P 535945

**ON-SITE SEWAGE DISPOSAL SYSTEM
 HOWARD COUNTY HEALTH DEPARTMENT
 BUREAU OF ENVIRONMENTAL HEALTH**

4410 Salem Bottom Rd

LOCATION DRAWING
12857 LIME KILN ROAD
LOT 17
LIME KILN VALLEY
PHASE I & II
ELECTION DISTRICT NO. 5
HOWARD COUNTY, MARYLAND

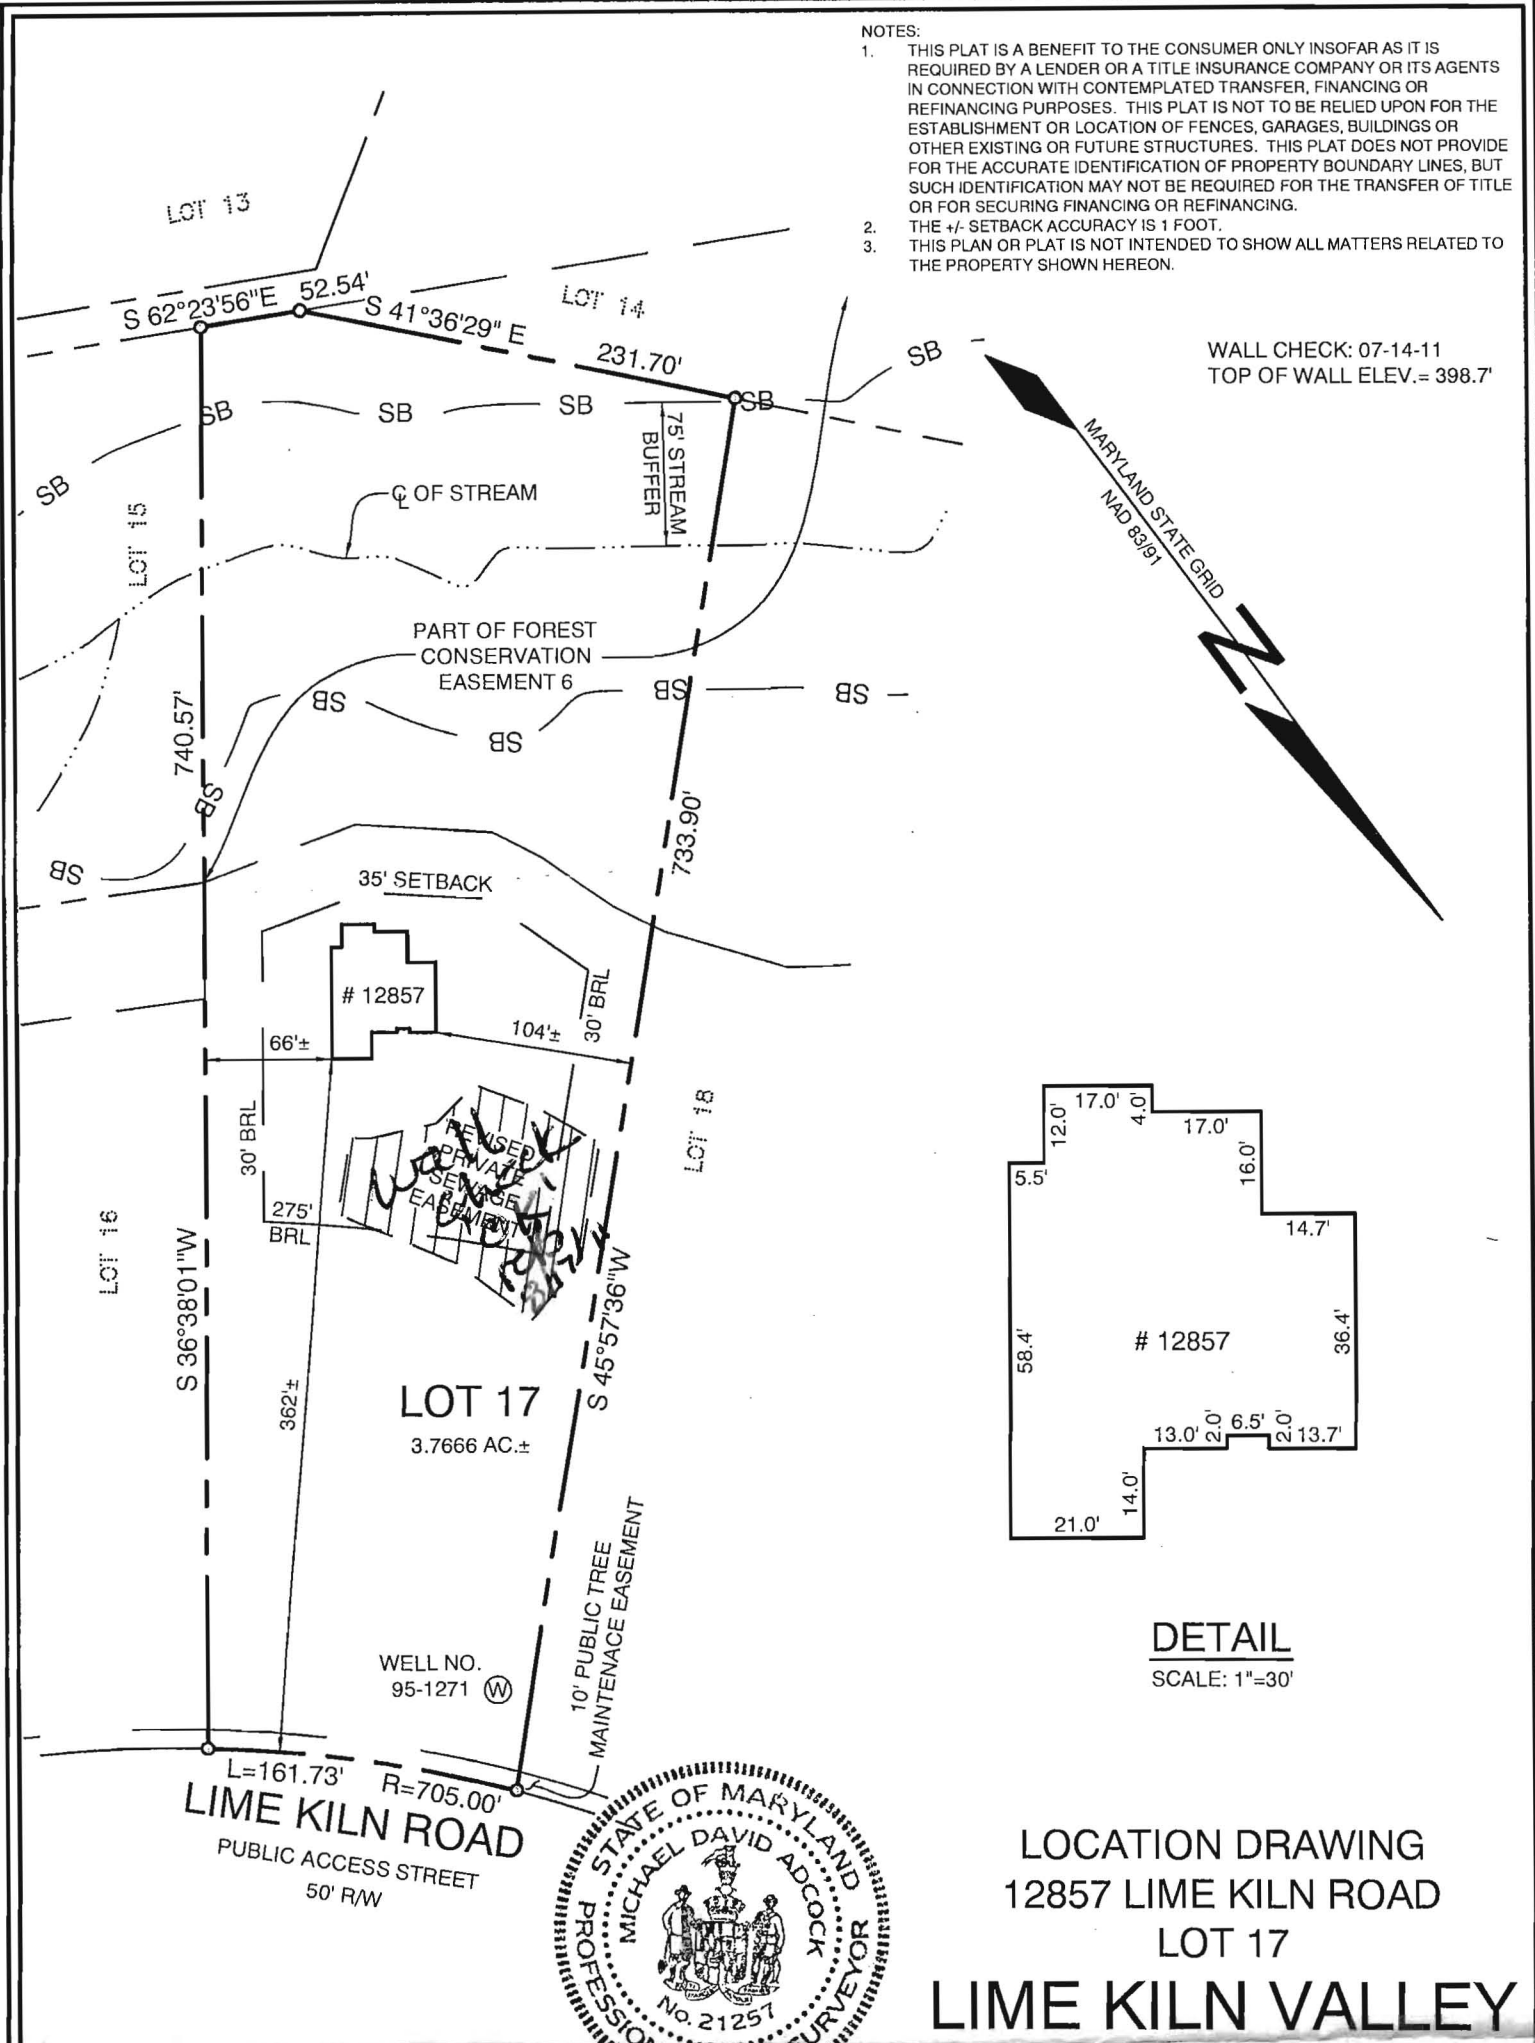
9/20/11 No water in p.i.t. Electrical problems
w/ pump. (KW)
9/22/11 P/A test OK.

8/22/2011 Did trench layout. Contractor wants easement cleared of trees before starting. Install a 40' and two 50' trenches on contour in top of northern part of easement. Grading needs to be done before installing tanks and pump line. Keep tanks out of proposed swale. (KW)

INSTALLATION: 9/6/11 Explained to contractor that depending on where the swale will lie, tanks must be placed away from center of swale. Level spreader cannot be avoided. (KW) 9/12/11 Explained that well line must be 10' removed from pump line of sept. Contractor explained that he will be able to make 10'. (KW) 9/13/11 Contractor finished trenches w/ D box. Tanks set as explained on 9/6/11. Need F.M. and manholes/baffles (KW)

9/15/11 Still need inlet baffle on s.t. FM complete. Need P/A test for final approval (KW)
